IEEE P 802.20™ V8C

Draft 802.20 Permanent Document

<802.20 Requirements Document – Ver. 8C>

Figure 3.1

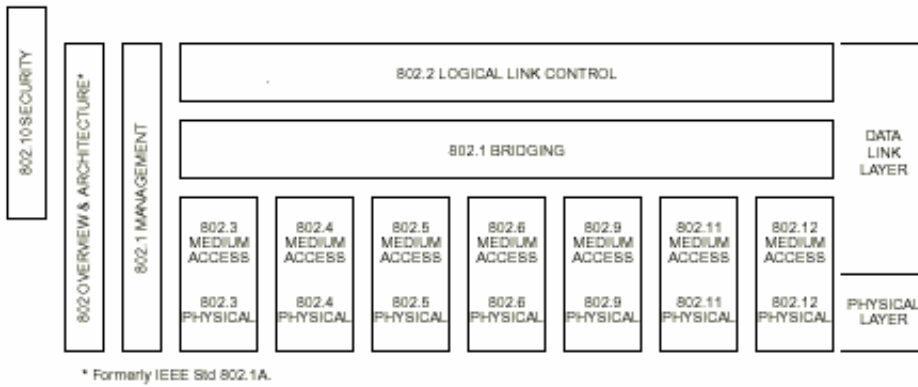
Comment: Editor Note: This represents a new version of this picture without any of the details that were in the original version.

4 *Action: Change the notations in the bubbles to point to the relevant section of the text (or*
5 *remove the bubbles).*
